ARM Group Inc.

January 24, 2018

Re: Response and Development Work Plan
Sub-Parcel B6-2 (Revision 1)
Responses to Agency Comments
Tradepoint Atlantic
Sparrows Point, MD 21219

ARM Group Inc. Earth Resource Engineers and Consultants www.armgroup.net	TYPICAL UTILITY CROSS SECTIONS Sparrows Point Site EnviroAnalytics Group, LLC		January 2018	Figure 1
			1/2" = 1'-0"	
			160443M

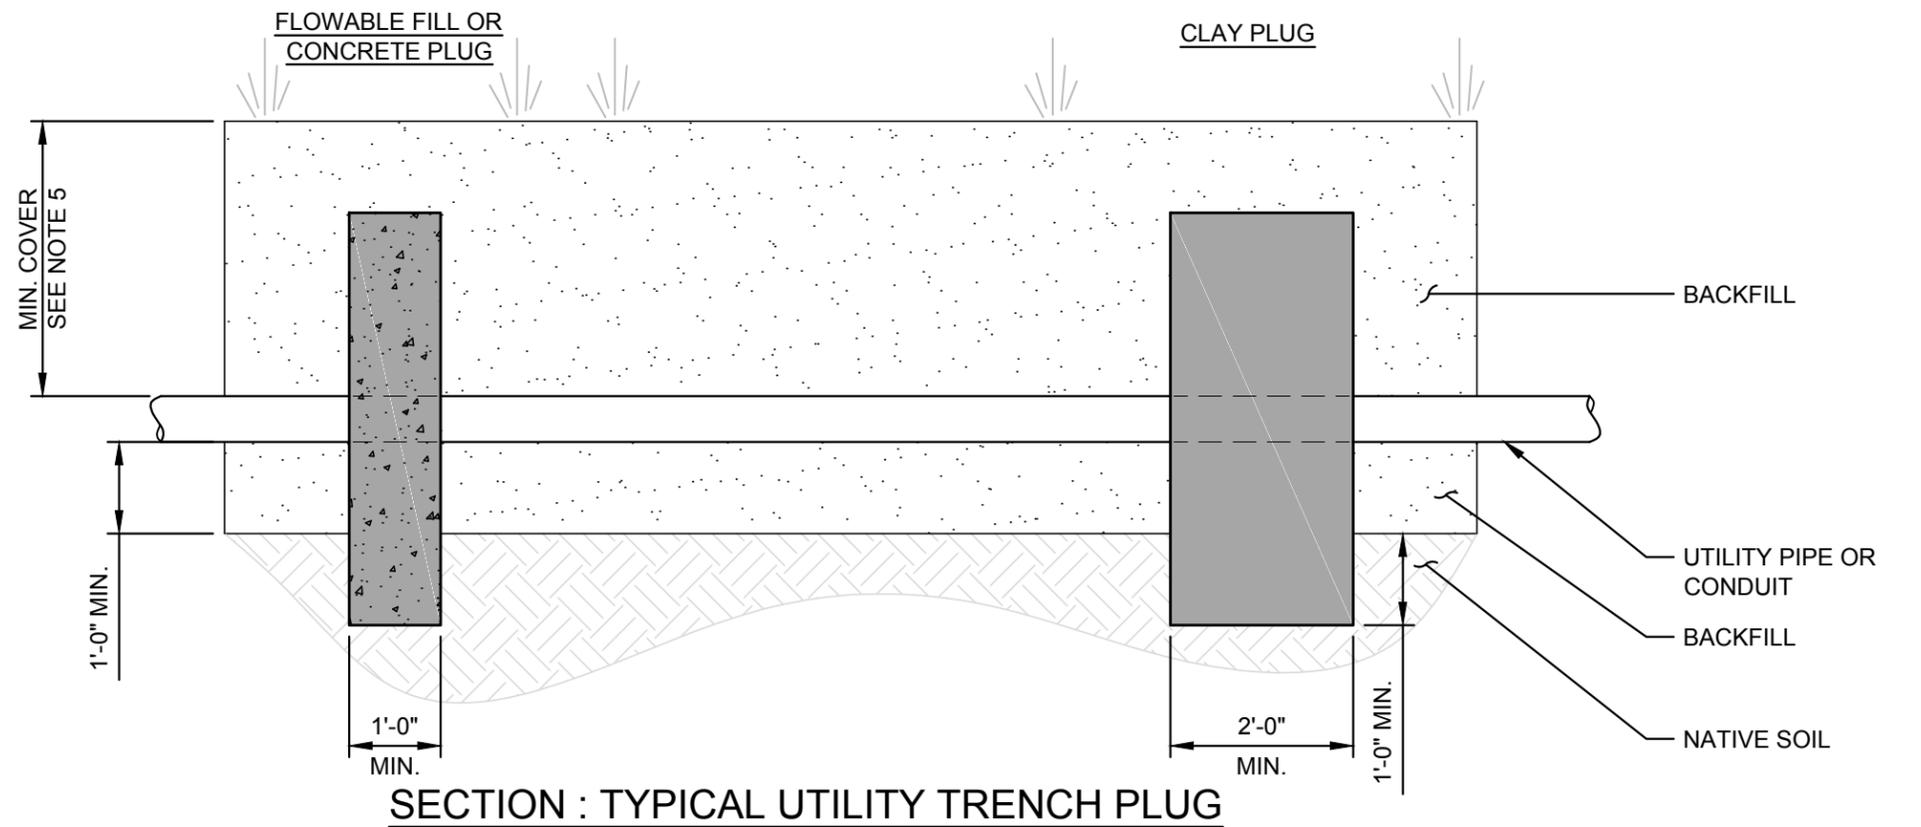
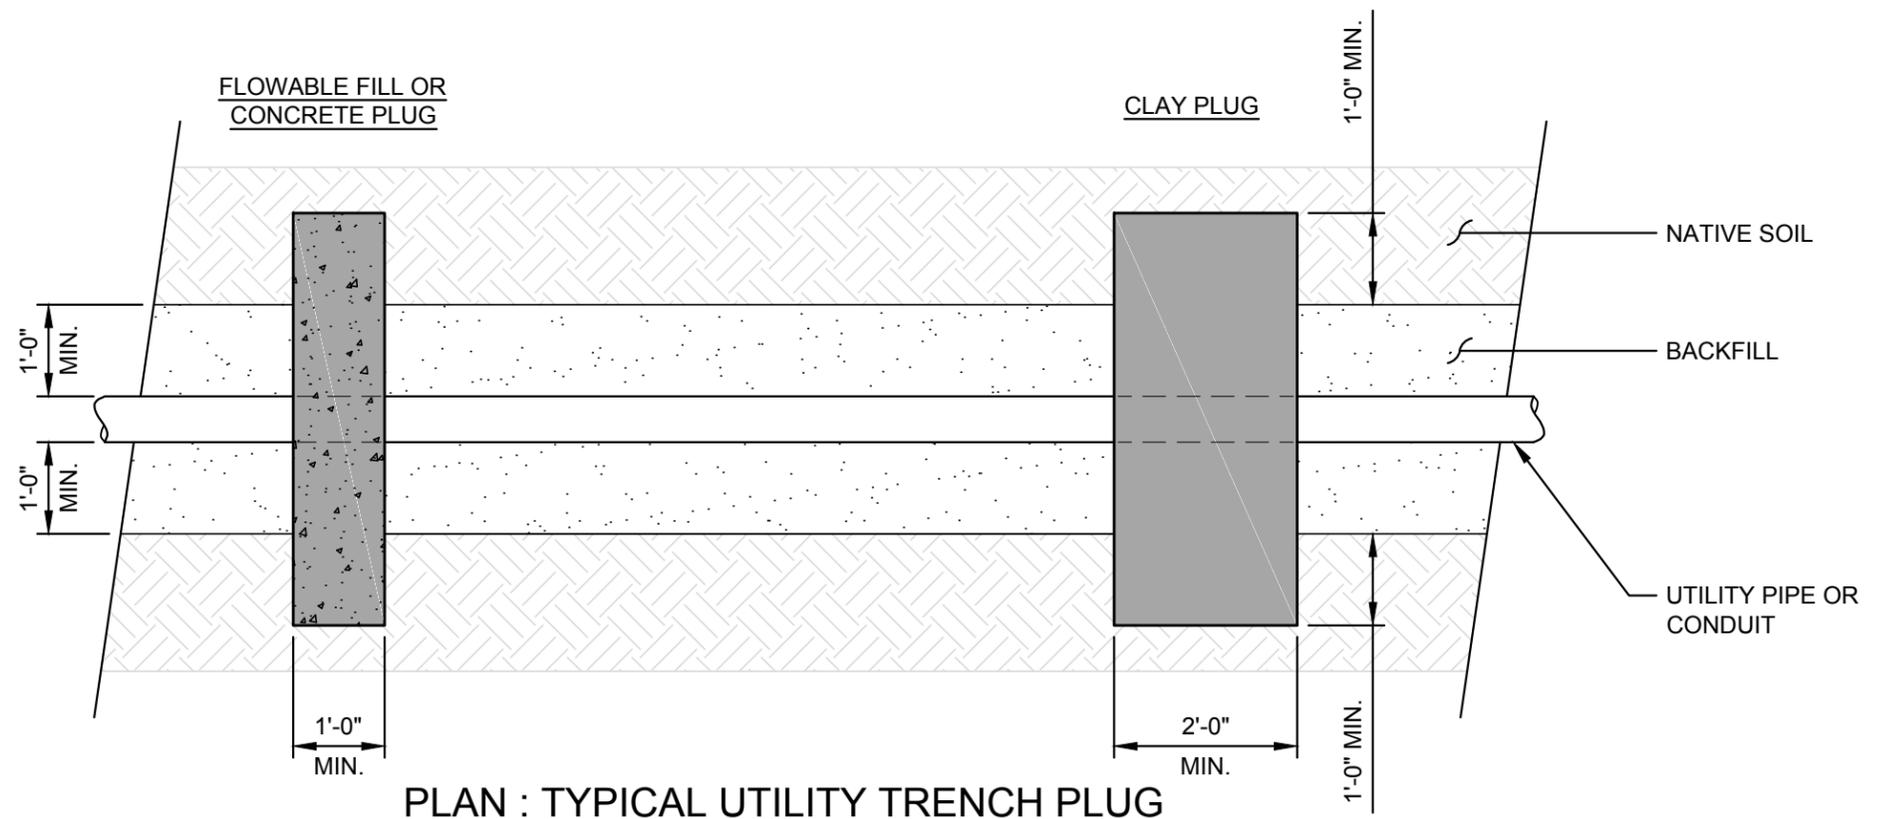
As stated in item #10b, the force main is no longer proposed to the west of the main development area. Therefore, there are no special restrictions for utility fill, etc. since all utilities will be installed within the footprint of the Composite Worker Area which requires a capping remedy. As stated in item #7, references to MDE-approved materials have been clarified in this RADWP. In addition, a new typical utility cross section drawing has been prepared and is included as **Appendix H**, replacing the prior version (formerly **Appendix G**). A revised trench plug figure has also been included with this letter to be incorporated into the NAPL Contingency Plan found in **Appendix I** (formerly **Appendix H**). The revised trench plug figure includes minor formatting modifications and a new note referencing the typical utility cross section drawing.

1. ALL PIPES OR CONDUIT PASSING THROUGH AREAS OF PETROLEUM CONTAMINATION SHALL BE LEAK-PROOF AND WATERTIGHT. ALL JOINTS SHALL BE SEALED OR GASKETED.

7. FOR ADDITIONAL REQUIREMENTS, INCLUDING THE USE OF MDE VCP CLEAN FILL FOR COMMERCIAL LAND USE AND INSTALLATION OF GEOTEXTILE MARKER FABRIC, REFER TO NOTE 5 ON THE TYPICAL UTILITY CROSS SECTIONS.
